Construction of 4.97 km Elevated viaduct from Koteswar Raod dead end to start of ramp of underground section, including 4 nos. Elevated stations viz. Ashram Road, Koteswar Prachin Mandir, Sabarmati River, Sardar Nagar and Design, construction and completion of 1.01 km of underground section comprising of twin cut & cover tunnel between ramp to dead end, including ramp and 01 no. Underground Metro station for Ahmedabad Metro Rail Project, Phase-2A

Tender No.GMRC/CONS/STNS+VDCT+UG/PH-2A/2026

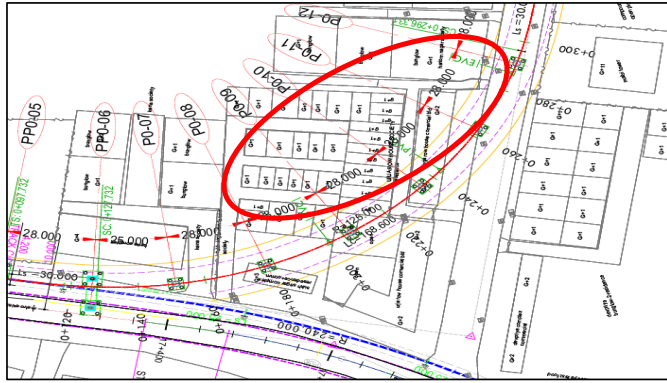
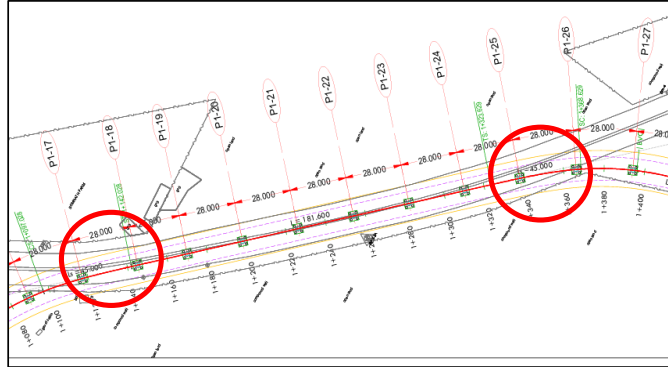
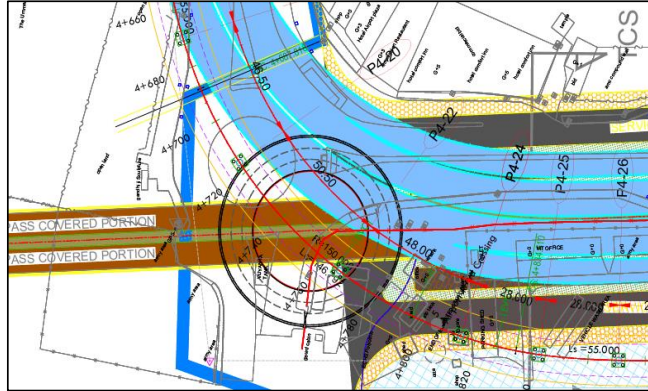
99	3	Employer's Requirement - Elevated	Appendix 2A		Provision and disposal of earthworks material iii. All excavated material, excluding waste material, polymer fluid and polymer contaminated material shall be disposed of at the appointed site only. This material shall be placed and compacted in accordance with the Construction Specification for Earth Works or as otherwise directed by the Engineer's Representative. The disposal of waste material, polymer fluid and material contaminated with polymer shall be the full responsibility of the Contractor and these materials shall be disposed of by the Contractor at an approved location. The dumping sites provided by the Employer shall not be used for disposal of waste material, polymer fluid or material contaminated with polymer.	Bidder request to provide the location details, Geo co-ordinates of appointed site identified by Authority for the disposal of C&D Waste.	Refer SN 16 & 17 of Addendum no. 1

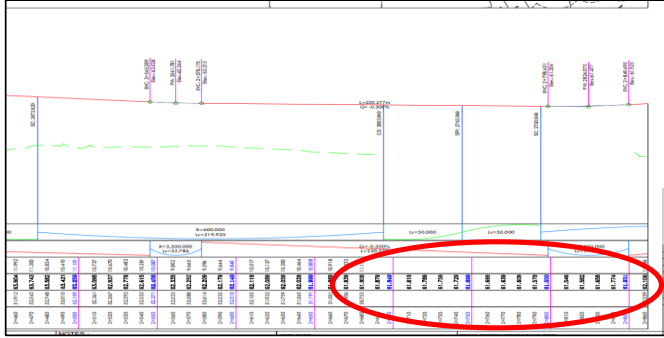
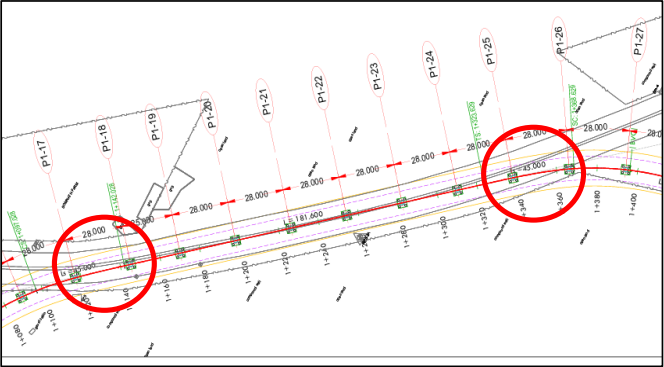
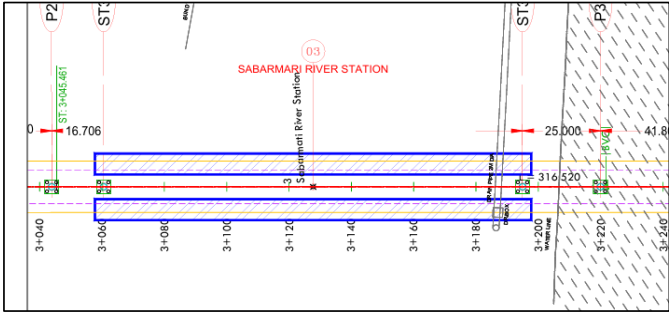
106	3	Employer's Requirement UG	7.6, Appendix 2B	5	KD - 6 - Start of first D-wall for station box.	The commencement of Dwall in Key date 6 has been mentioned. Request you to clarify if the contractor has to adhere to construction of Diaphragm wall as retaining structure or the Contractor can modify the retaining structure as per his design.	Tender condition prevail.

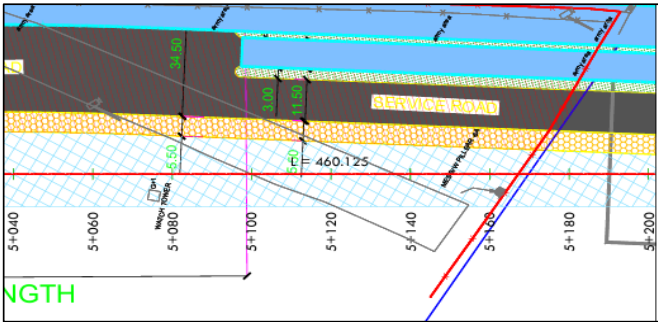
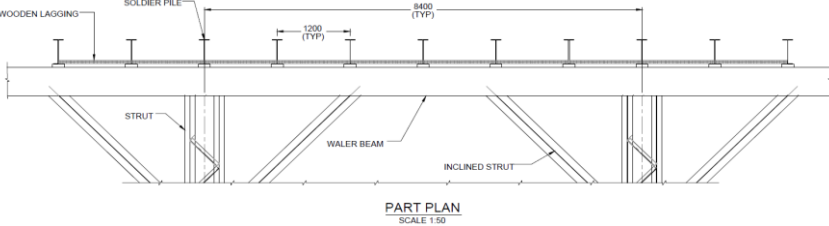
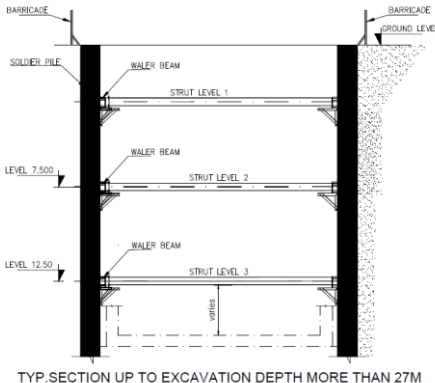
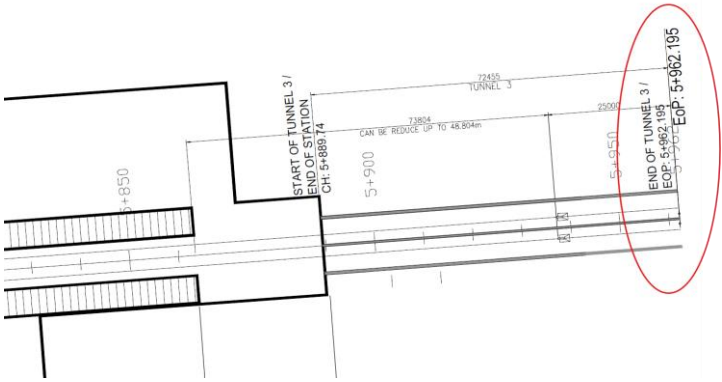
112	3	Employer's Requirement UG	(7.2) General A10.2	8	A10.2 IMPLEMENTATION OF BIM SYSTEM FOR CIVIL CONTRACTOR (i) Civil Contractor shall implement BIM system (Autodesk Forma) for executing and delivering the services set out in Agreement.	Bidder request to kindly clarify whether Autodesk Forma licenses/subscriptions shall be provided by the Client or shall be included in the Contractor's scope and cost.	Tender condition prevail.

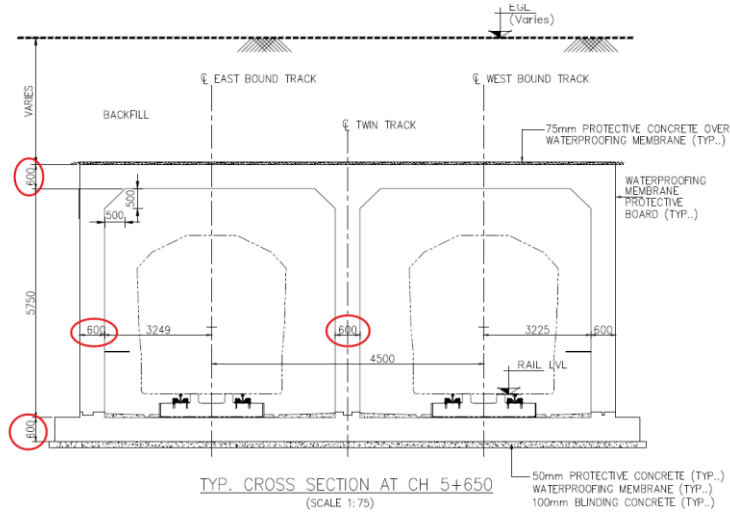
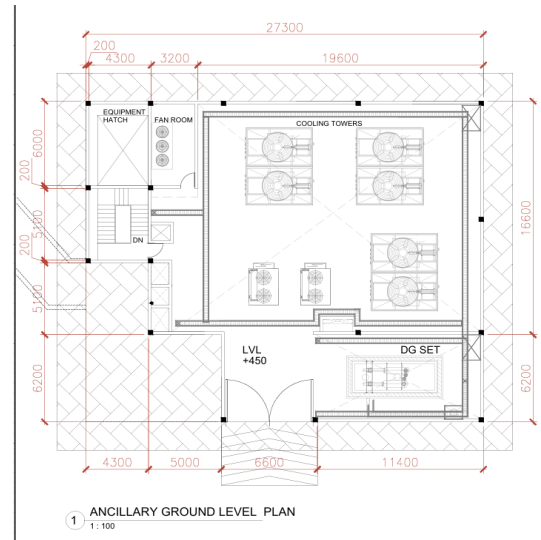
120	3	Employer's Requirement UG	Appendices Appendix 11	61	Horizontal and Vertical alignment All details with regard to the Horizontal and Vertical Alignment are shown on the plan & profile sheets of the drawings provided in Volume 5 of the tender document.	Bidder request Authority to confirm whether horizontal and vertical alignment for elevated section and underground section are freezed or the contractor has liberty to design the same as per specifications for underground section as UG section is design build mode.	Horizontal and vertical alignment of UG section and Elevated section are freezed, however possibility can be explored for optimized/better option during Detailed design stage by contactor, if any, with due approval of employer.

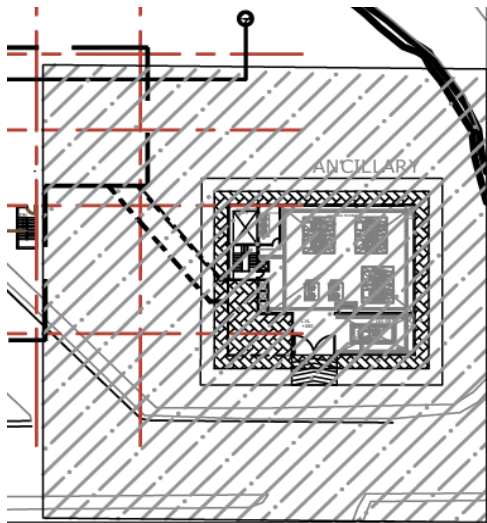
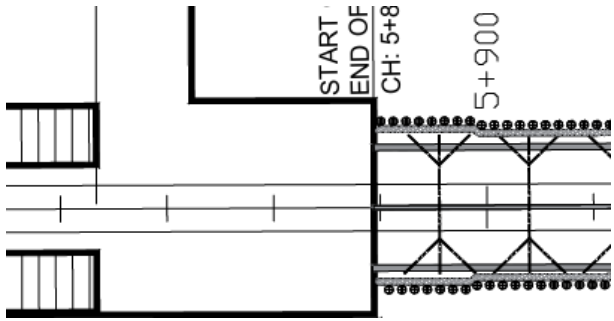
128	4	UG ODS	2.6.3	10 of 34	Flexural crack width shall be checked in accordance with latest IRS codes and correction slips,	Underground cut & cover and station structures are similar to underground building. Bidder request to Kindly confirm if IS456 can be used in place of IRS: CBC for crack width limit & calculation. o Its standard practice to use IS456 in UG structure design in India.	it is within the Design scope of contractor /DDC engaged by Contractor for UG section.
129	4	UG ODS	2.9	27 of 34	Service/Operation" – Maximum flooding level (above ground level) at 1 in 50 years plus 1.0 m.	Bidder request to Kindly provide HFL to be considered for UG structure design.	HFL to be considered at Ground Level for UG structure Design.

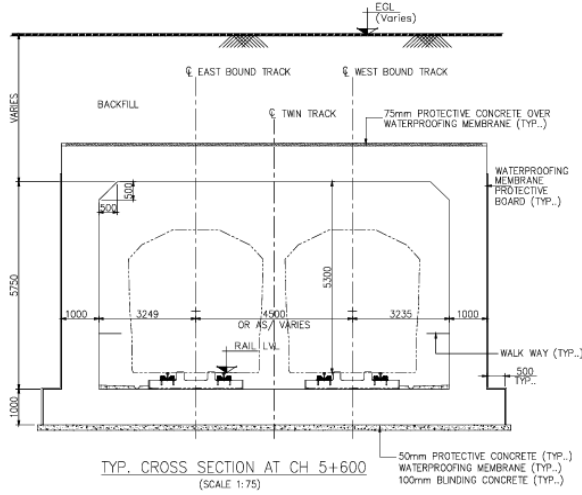
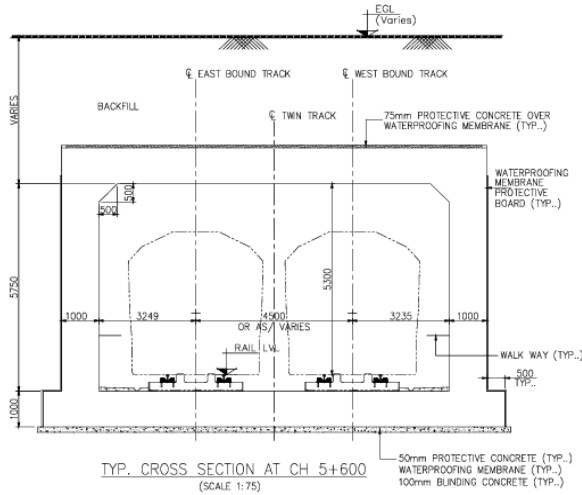
138	5	Tender Drawings	General Alignment	17	Drawing No - DDCPH2A&2B-TD-ELV-ST-DW-04223 (General Alignment) 	As per Drawing No. DDCPH2A&2B-TD-ELV-ST-DW-04223 (General Alignment), Spans of 46.50 m, 50.50 m and 48 m are observed. We request employer to provide the details of spans mentioned within GAD.	PSC/ Steel composite girder shall be proposed as per site requirement.
